July 6, 1989

EniChem Americas, Inc., would like to request the following revisions to our license (License No. 29-28080-01, Docket No. 030-30152, Control No. 107635) effective immediately.

FLOOR PLAN

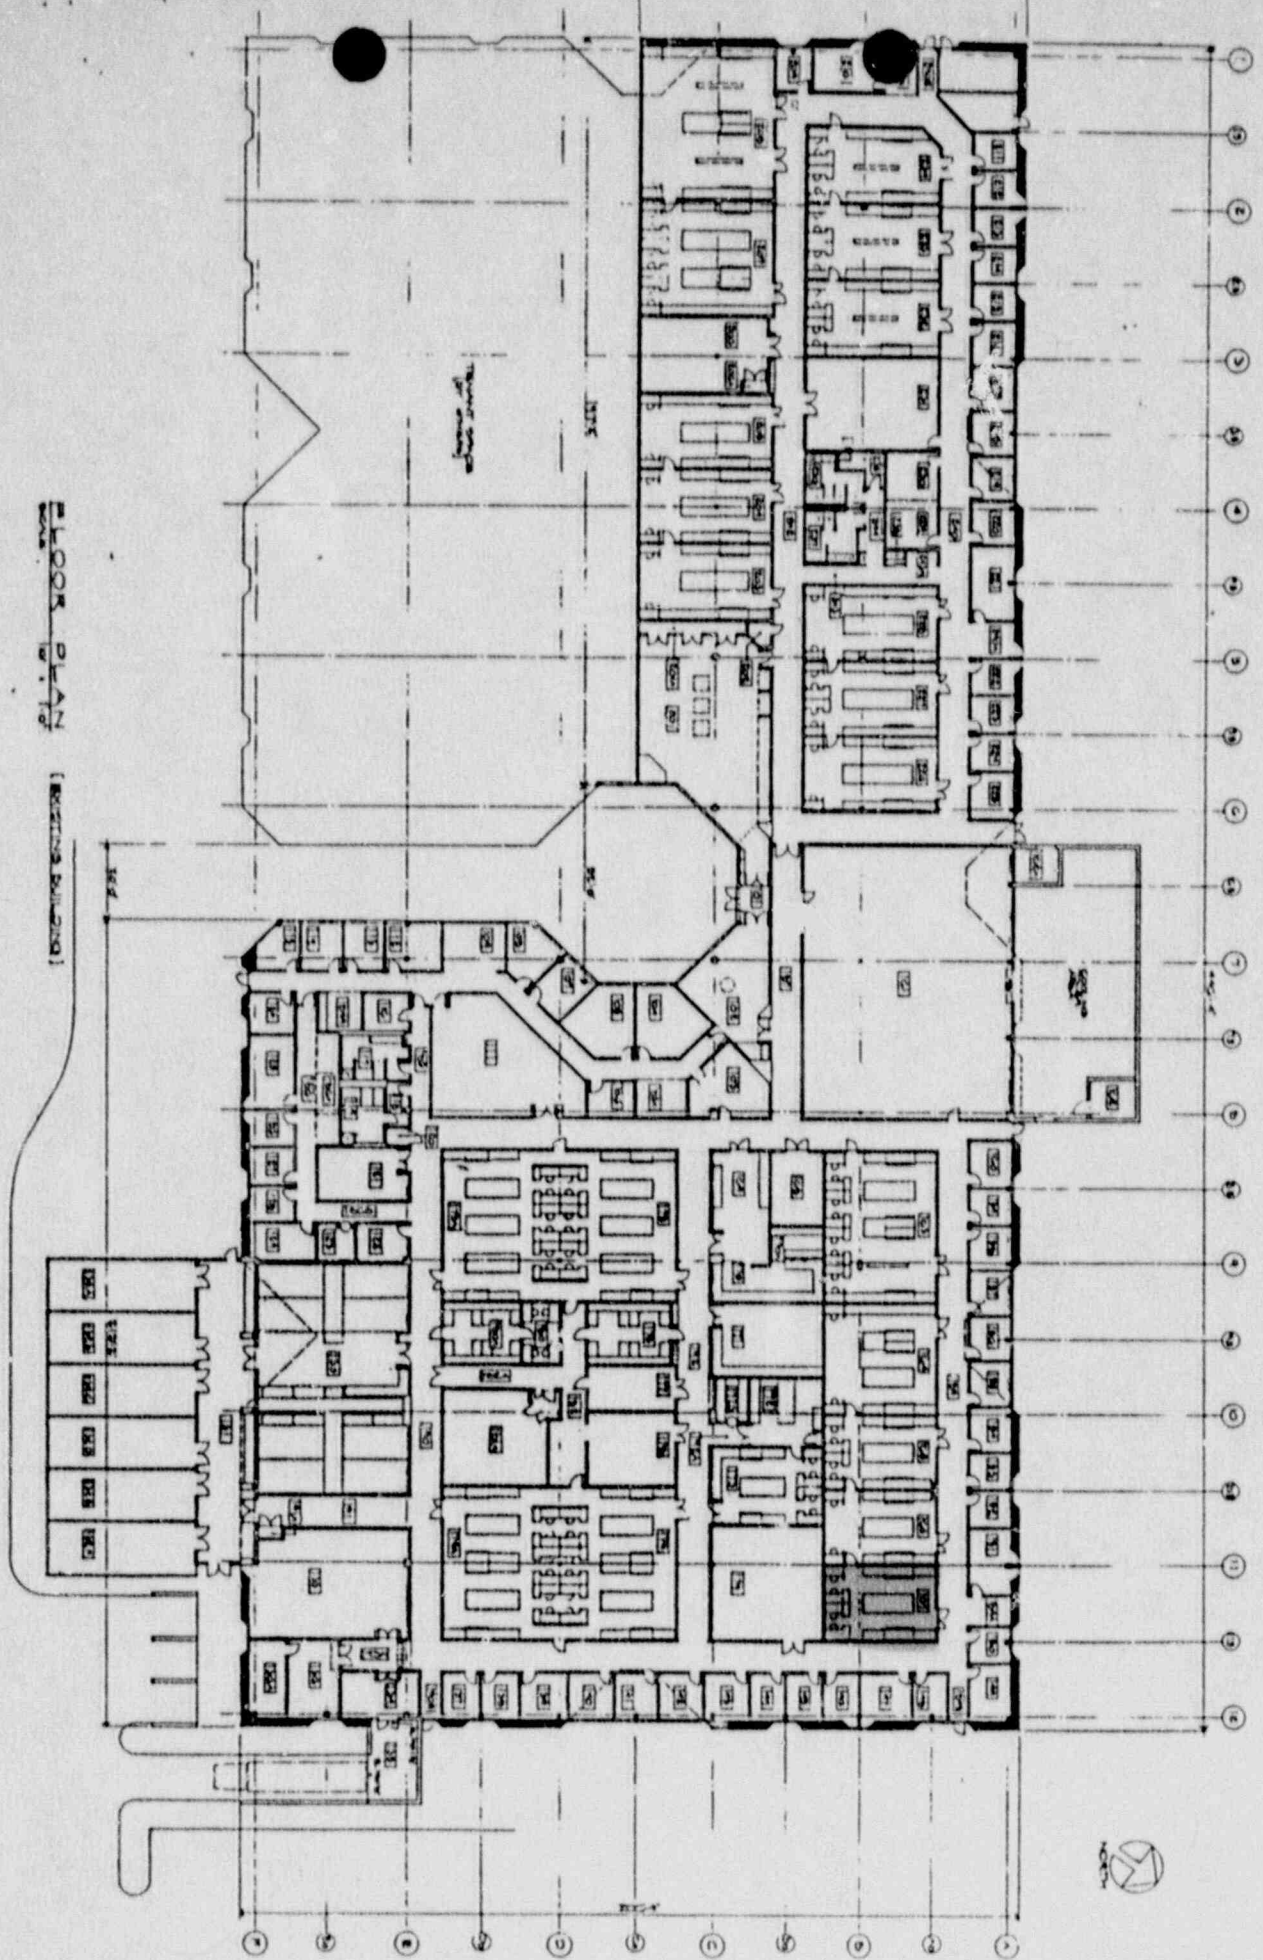
4. Since our original application was submitted, we have added a Chemical Synthesis group to our organization. The group occupies laboratory 167 (see attached diagram). This laboratory is constructed similarly to the other general laboratories previously approved for radioisotope use. We request approval to synthesize radiolabeled peptides, enzyme inhibitors and metabolic substrates in this laboratory for use in studies on protein stability, enzyme kinetics and metabolic fates in plants and soils.
